Steinbrueck Park

**Office of Planning and
Community Development**

April 21, 2016**9:00 - 10:30 am****Type**

Briefing

Figure 3: Proposed waterfront connection without connection to park (above) and with connection to park (below)

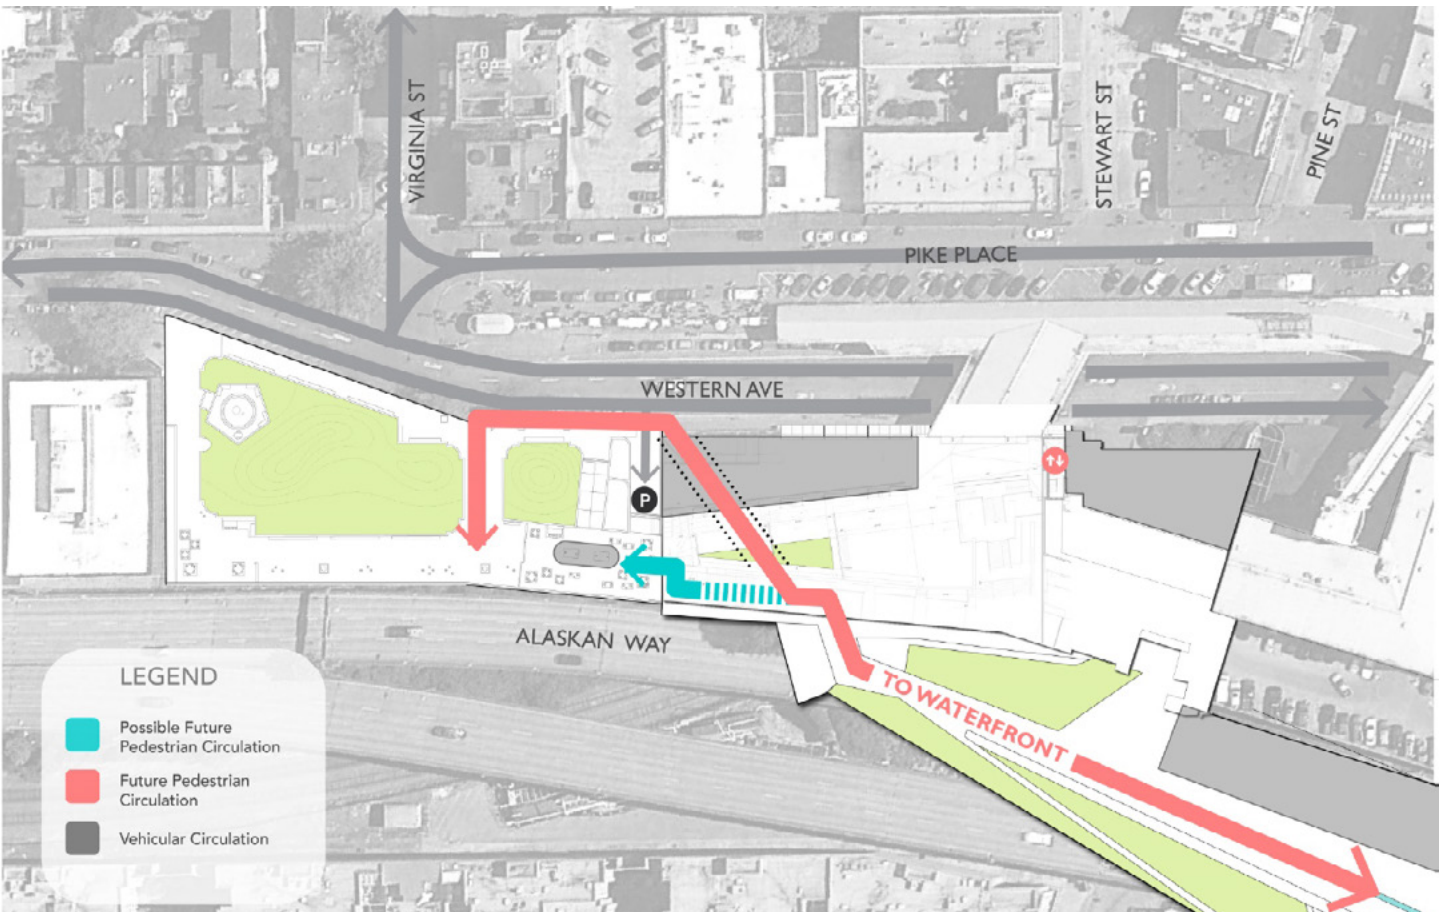
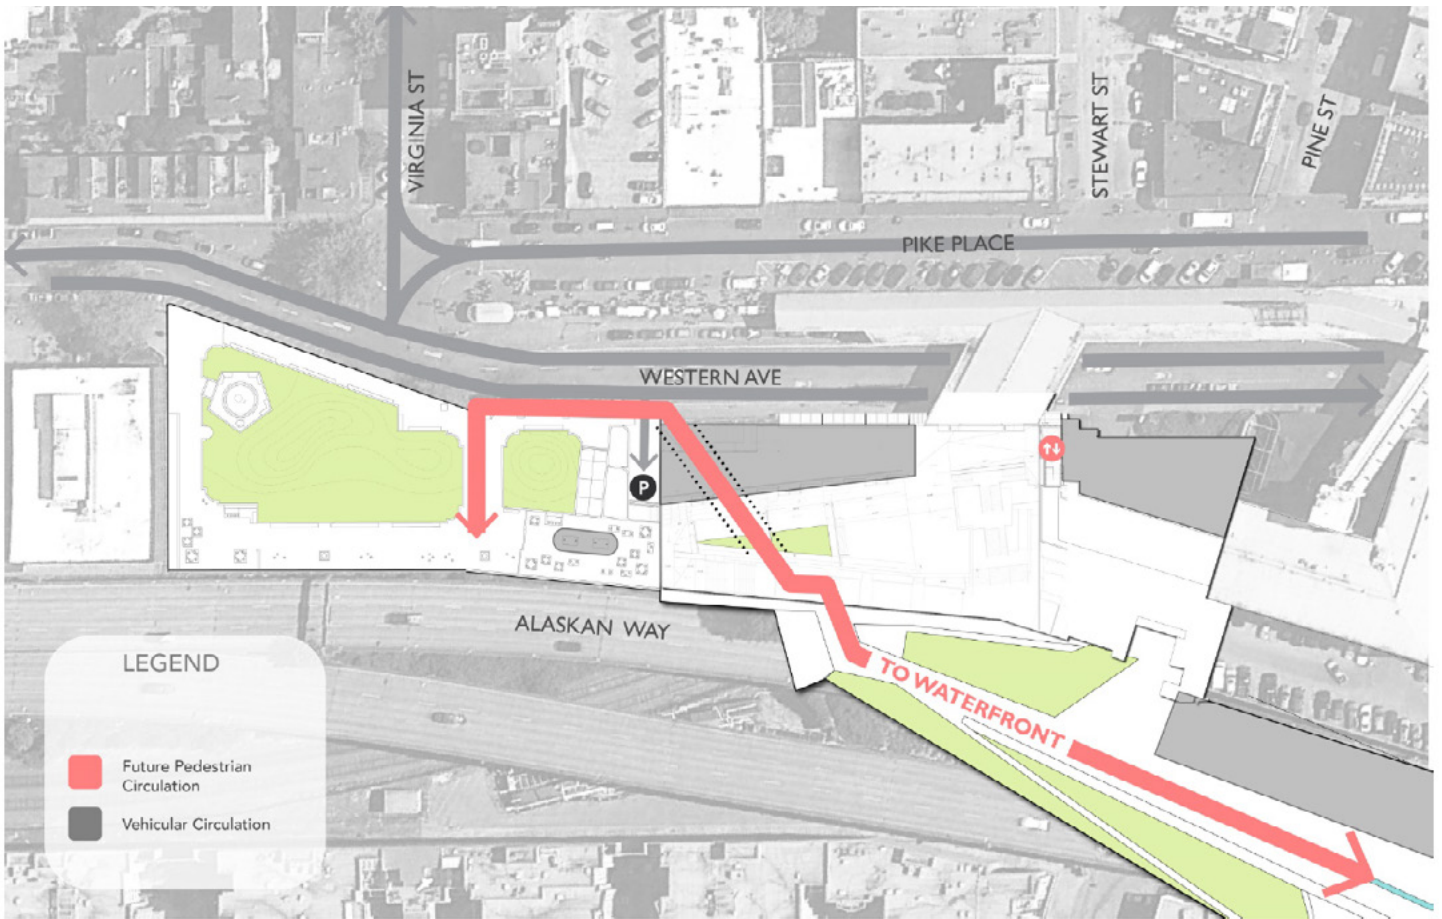
Heather McAuliffe, Pike Place Market Historical Commission, stated the Market Historic Commission is concerned with preserving the historic design of the park as well as preserving gathering space that Natives use every day of the year. She mentioned that this specific area of the park is not intended to be a connection area, but rather a living room for activity. Ms. McAuliffe further mentioned that the Committee does not disagree that there should be a connection to the park. Rather, the Commission feels a connection point should be located further east, outside of the living room.

The SDC supports a direct connection between Steinbrueck Park and the Marketfront. To accomplish this, the SDC recommended that the design team continue exploring ways to provide a direct connection without altering the historic aspect of the southwestern edge of the park.

At this meeting, The SDC endorsed the idea of providing a connection between Steinbrueck Park and the adjacent Marketfront and Overlook Walk projects. The Commission recommended the project team provide a connectivity point while preserving the original design intent of the park. The SDC also endorsed the idea of continuing outreach with community members and user groups.
